SNARE HYDRO SYSTEM

2006 Comprehensive Dam Safety Review

A Comprehensive Dam Safety Review (DSR) of the Snare Hydro System was performed by Klohn Crippen Berger Ltd. (KCBL) between July and December 2006. The DSR was performed in accordance with Section 2 of the Canadian Dam Association, Dam Safety Guidelines.

Figure 9-4: Snare Forks – 2005 Crest Survey: Dyke 1, North Dyke & Strutt Lake Dam

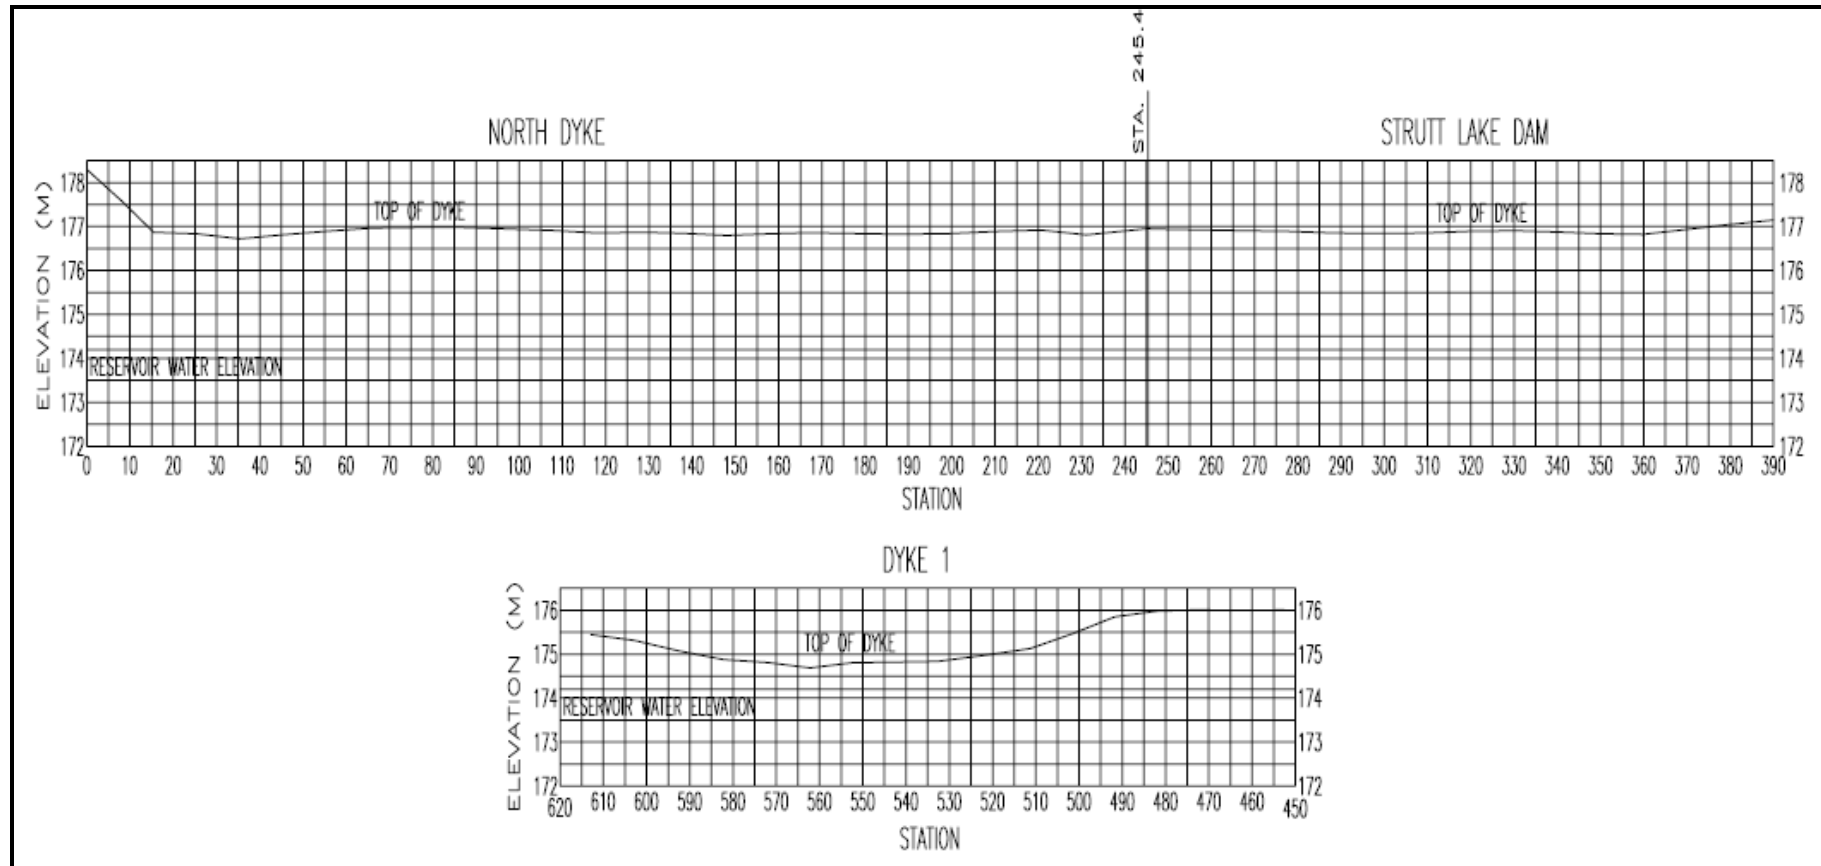
An August 2005 centreline survey (see Figure 9-4) shows the crest of Strutt Lake Dam ranging from EL. 176.82 m (EL. 580.1 m) to EL. 176.94 m (EL. 580.5 ft), all above design grade. The survey also shows the North Dyke crest elevation ranging from EL. 176.72 m (EL. 579.79 ft) to EL. 176.95 m (EL. 580.5 ft), i.e. within 0.06 m of design level. The North Dyke has been topped up since the 2005 survey and the most current survey therefore does not reflect the conditions at the time of the inspection. A new crest survey is therefore considered prudent to document current conditions.
